RE: Project File Number 606376,
Proposal for Immediate, Near-Term,
and Long-Term Improvements to
Cambridge Street Bridge over I-90,
Allston, Boston, Massachusetts

I am submitting these comments about the Cambridge Street project following attendance at the November 19 public meeting.

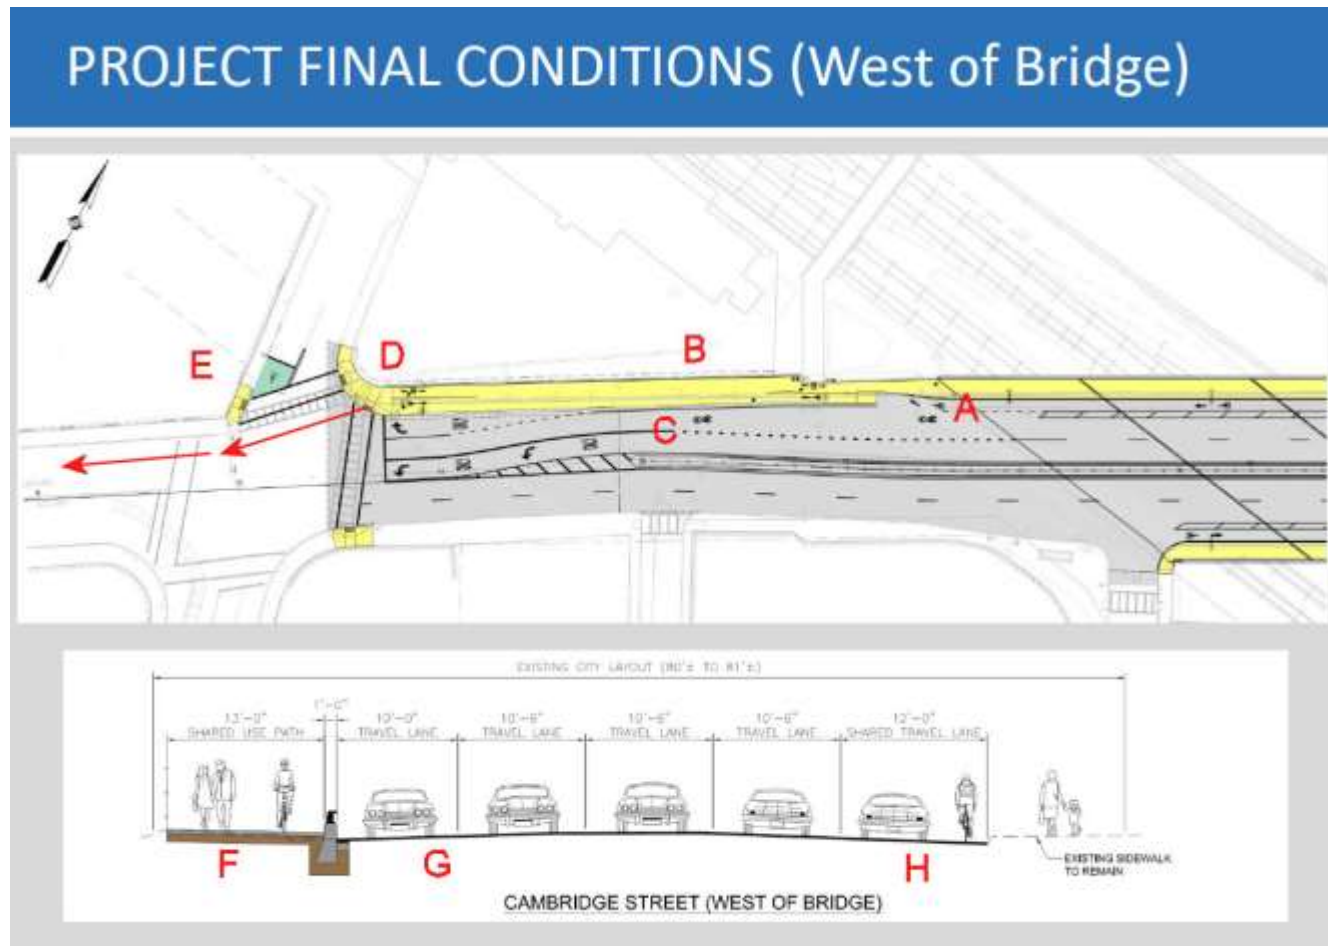
In connection with my further comments, please refer to keys (letters in red) which I have inserted into the image below which I copied from a drawing shown at the November 19 meeting.

The shared-lane markings in the through lane of Cambridge Street indicate a line of travel for bicyclists who wish to continue on Cambridge Street. The second shared-lane marking (at C in the drawing), is well-placed but the first one is oddly placed so as to suggest an abrupt merge out of the buffered bike lane on the bridge. The buffer for the bike lane should be replaced with dashes earlier so as to allow a safe merge. Shared-lane markings might also be placed in the left-turn lane. I also suggest doing away with the buffer and simply making a wider bike lane. Cyclists will still then be able to ride closer to the curb if they prefer, but will not be riding over bumpy diagonal stripes to overtake or in winter when the area near the curb is a mountain of plowed snow.

I agree with other commenters that routing westbound bicyclists onto the sidewalk is undesirable. Bicycle traffic for North Allston can more easily turn right at Lincoln Street, taking a shorter route and avoiding the climb over the Cambridge Street Bridge. Westbound bicycle traffic on Cambridge Street would be traveling fast coming down off the bridge, and would encounter multiple conflicts at the end of the Franklin Street overpass, with its entering and exiting traffic, then have to cross left to the right across oncoming bicycle and pedestrian traffic. (The drawing, at F, shows only a single bicyclist headed westbound on the left side of the path!) Taking bicycle traffic onto the sidewalk greatly increases the volume of traffic there, compared with the

light traffic to and from the Franklin Street overpass. If the excess traffic is avoided, the width of the sidewalk/shared-use path between Franklin street and Linden Street (B through D in the image) becomes excessive.

I suggest eliminating the ramp, and a narrower sidewalk, still capable of handling the two-way traffic to and from the overpass, allowing continuation of the bike lane on the street to the left of the right-turn lane – if a right-turn lane is really necessary. Narrowing the median also would allow more roadway width.

At Harvard Avenue, westbound through bicycle traffic would have to merge back into the stream of traffic at the intersection. (See red arrows in drawing above.) The intersection of Cambridge Street and Harvard Avenue is the major choke point in the area. Reducing the number of traffic movements at this intersection would relieve some of the problems.

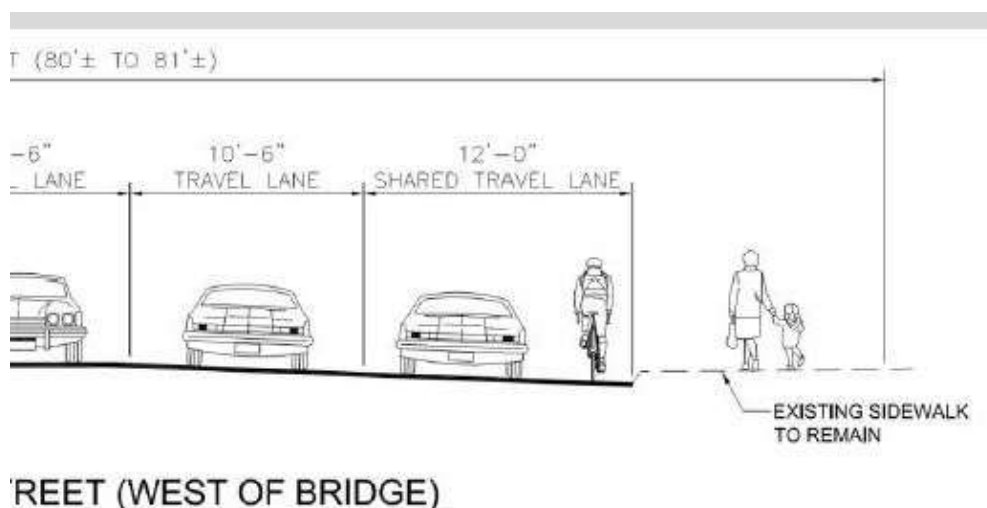
On this issue, I note point #2 on the Web page, “Improve the Cambridge Street Overpass”, complaining of “No bike lane between Harvard Ave & Linden St when travelling towards the river.” But there is no room for a bike lane in the proposed street layout, shown in the drawing below!

The drawing above, an enlargement from the previous drawing, shows a 10 ½-foot travel lane adjacent to the median, and a 12-foot right-hand travel lane. The right-hand eastbound lane is shown with a bicyclist and motor vehicle side by side, but **12 feet is entirely inadequate and substandard for side-by-side lane sharing of bicycles and motor vehicles, with or without a bike lane**, and especially when the next lane is narrow. The specified width for a bike lane is given as 5 feet in the Massachusetts Project Development and Design Guide, Chapter 16, http://www.massdot.state.ma.us/Portals/8/docs/designGuide/CH_16.pdf.

The cars shown in the drawing scale accurately to the width of a medium-sized sedan such as a Ford Taurus, 6 feet. However, the travel lane will also be used by larger vehicles including large trucks with overhanging rear-view mirrors – up to 10 feet wide mirror to mirror. Bicyclists will be traveling uphill, slowly. A 5-foot bike lane would leave only a 7-foot adjacent travel lane.

The problem can be solved or at least mitigated by avoiding profligate use of street width. The wide north-side sidewalk, right-turn lane, median and striped gore take a heavy toll on the width available for eastbound travel. As I've suggested above, the north sidewalk can be narrower. I also suggest that the median be reduced to a Jersey barrier, and the striped gore to a centerline. The only other safe alternative is for bicyclists to ride in the middle of the right lane while climbing onto the bridge. Many will do this and many others will not.

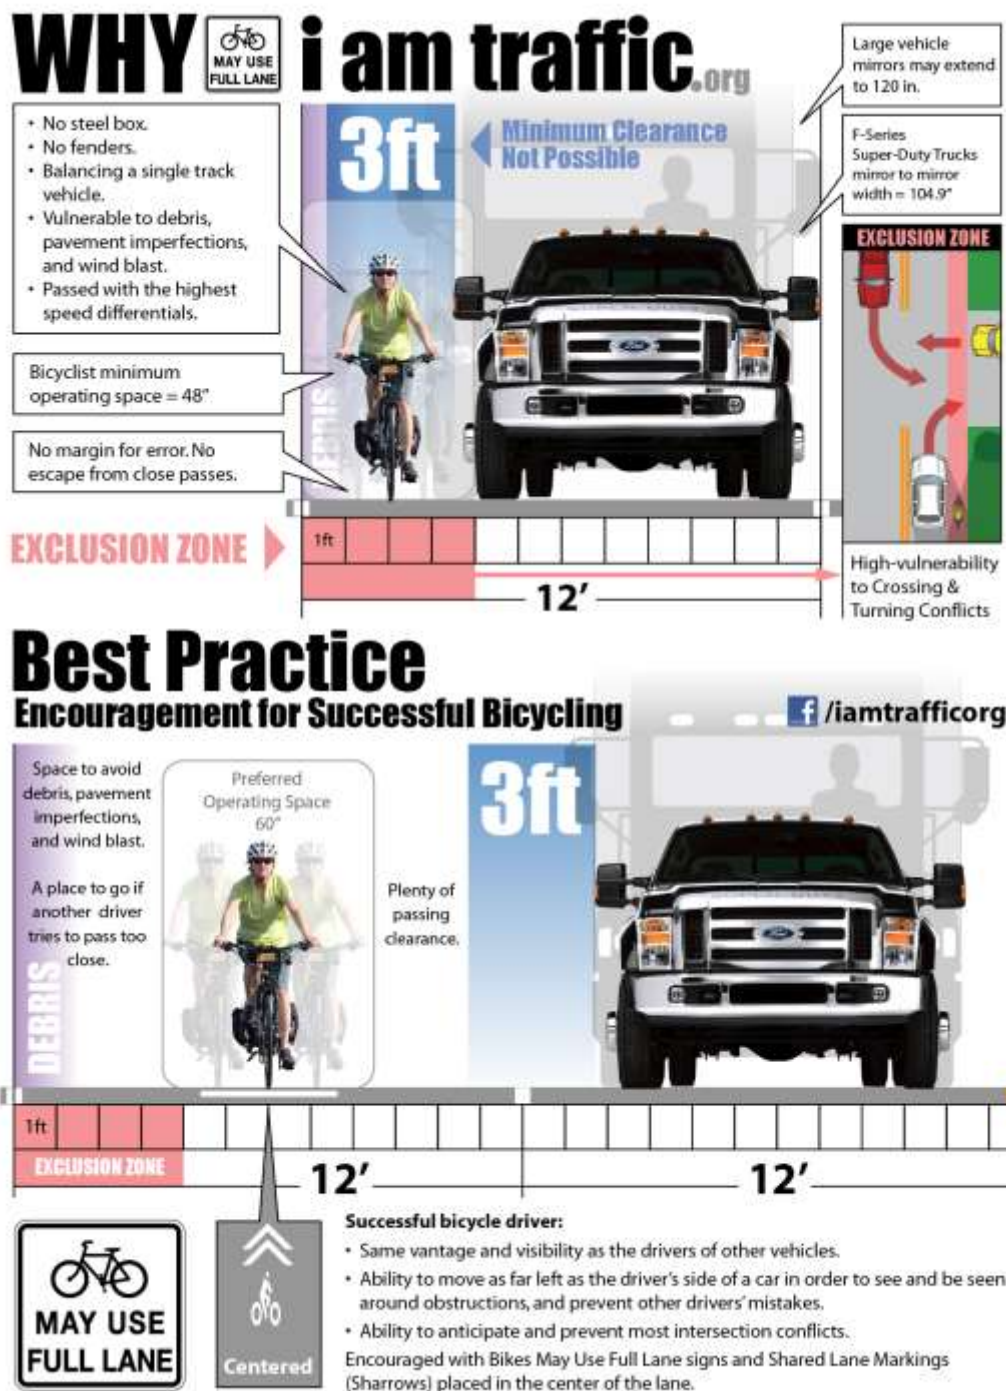
The drawing below from <http://iamtraffic.org/resources/infographics/>, shows, to scale, the overtaking clearances for a Ford F-150 pickup and a large semitrailer truck adjacent to a bicyclist in a 12-foot lane. The clearance next to a large truck (shown as the gray shading) is *less than zero* with the left mirror directly over the lane line to the left of the truck – not reasonable if another 10-foot-wide truck is overtaking in a 10 ½-foot lane.

As the lower panel of the drawing shows, the bicyclist can only avoid this problem by riding in the center of the travel lane so that the truck must merge to the next lane to overtake.

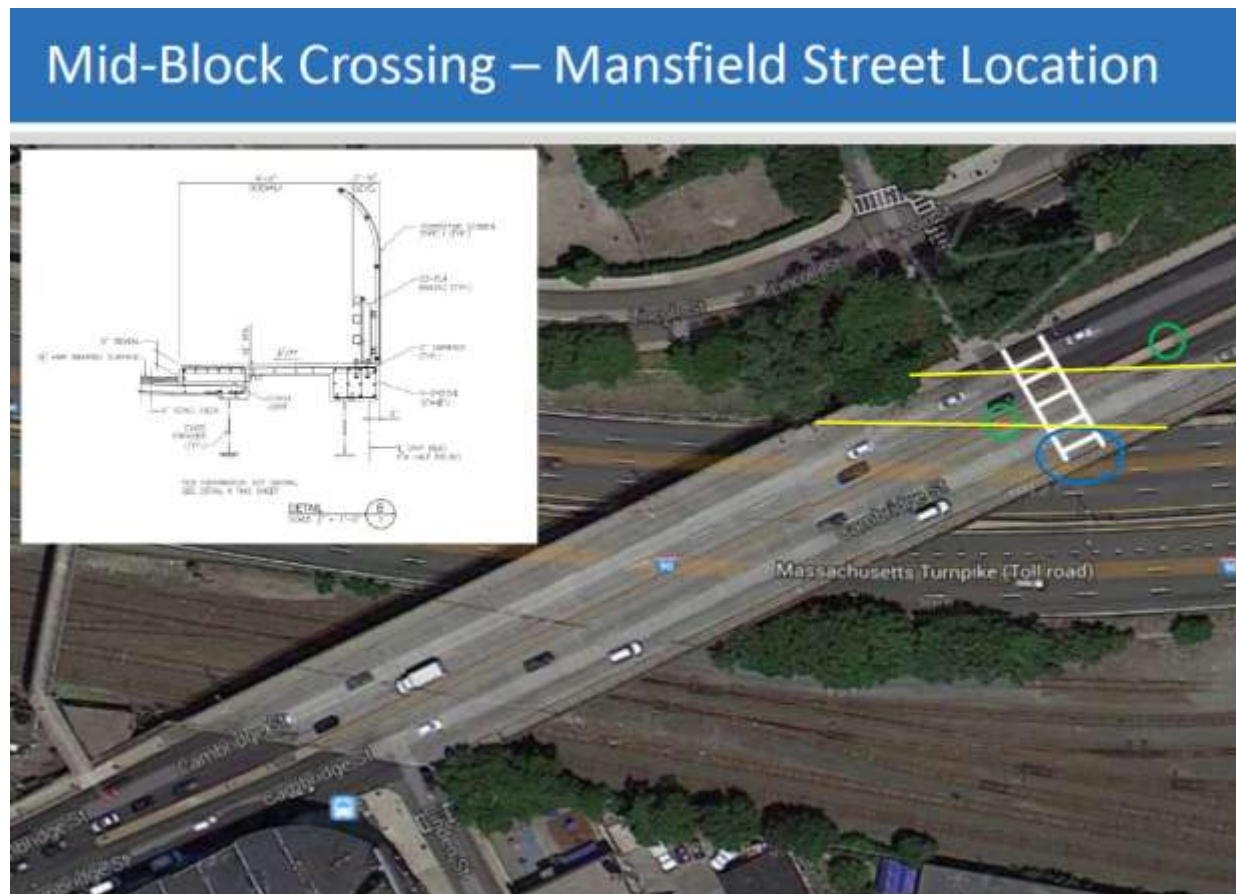
The proposed crosswalk at the Mansfield Street stairs (see image below, from the November 19 presentation) could shorten some walking trips between North Allston and Allston Village. An additional set of traffic lights here would delay traffic on Cambridge Street, so the signals should be actuated as well as timed, and to reduce traffic volume at the crosswalk, pedestrian and bicycle traffic might also be accommodated with shared-use paths under the bridge, alongside the Turnpike – see suggestions below. Access to a crosswalk would require extensive reconstruction of the Mansfield Street stairs to meet ADA requirements.
